Project	IEEE 802.16 Broadband Wireless Access Working Group < http://ieee802.org/16 >
Title	Text Enhancement for Project 802.16m Requirements: 9.2.3 Deployment with Multi-hop Relay Network
Date Submitted	2007-4-30
Source(s)	I-Kang Fu, Chi-Fang Li, Ting-Chen Song, Wern-Ho Sheen IKFu@itri.org.tw NCTU/ITRI ED922, 1001 Ta Hsueh Rd., Hsinchu, Taiwan300, ROC Peter Wang, Adrian Boariu peter.wang@nsn.com Nokia Siemens Networks 6000 Connection Drive, Irving, TX, USA
Re:	IEEE 802.16m-07/013: "Call for Comments and Contributions on Project 802.16m Requirements: <i>IEEE 802.16 Advanced Air Interface</i> "
Abstract	This contribution provides the text enhancement for Project 802.16m Requirements, which is the amendment of section 9.2.3 Deployment with Multi-hop Relay Network.
Purpose	Provide the text enhancement to state the reason why TGm need to consider multi-hop relay network architecture.
Notice	This document has been prepared to assist IEEE 802.16. It is offered as a basis for discussion and is not binding on the contributing individual(s) or organization(s). The material in this document is subject to change in form and content after further study. The contributor(s) reserve(s) the right

Figure. 9.x Coverage extension by deploying RS into IEEE 802.16m network

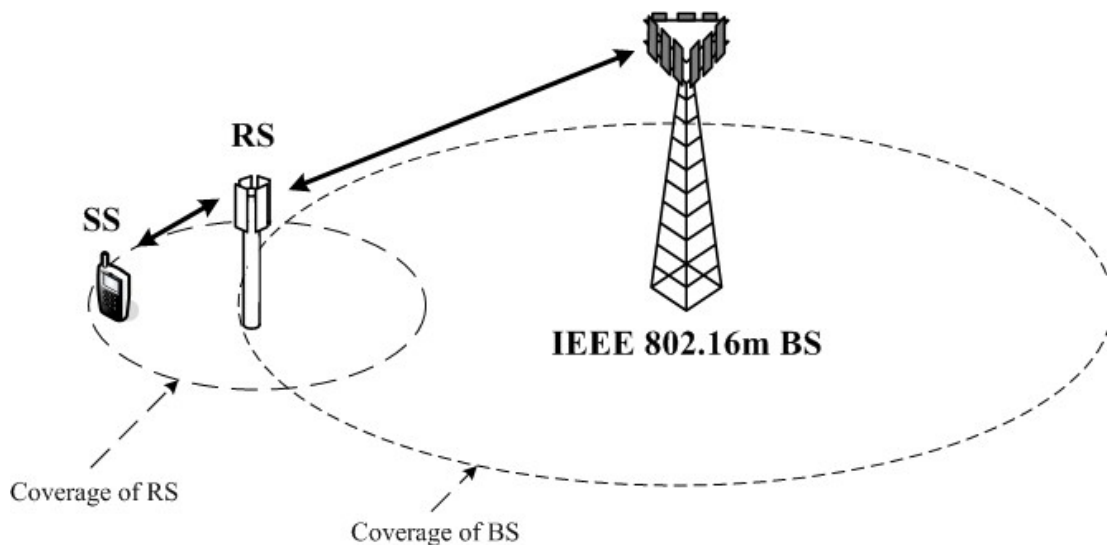
Deploying RS can improve IEEE 802.16m network in different dimensions. The following are some examples: First, it can extend the coverage of IEEE 802.16m BS, as shown in Figure 9.x. Second, it can enhance the transmission rate for the SS located at shaded area or cell boundary, which is shown in Figure 9.x+1. Third, it can achieve more aggressive radio resource reuse within the cell, as shown in Figure 9.x+2.
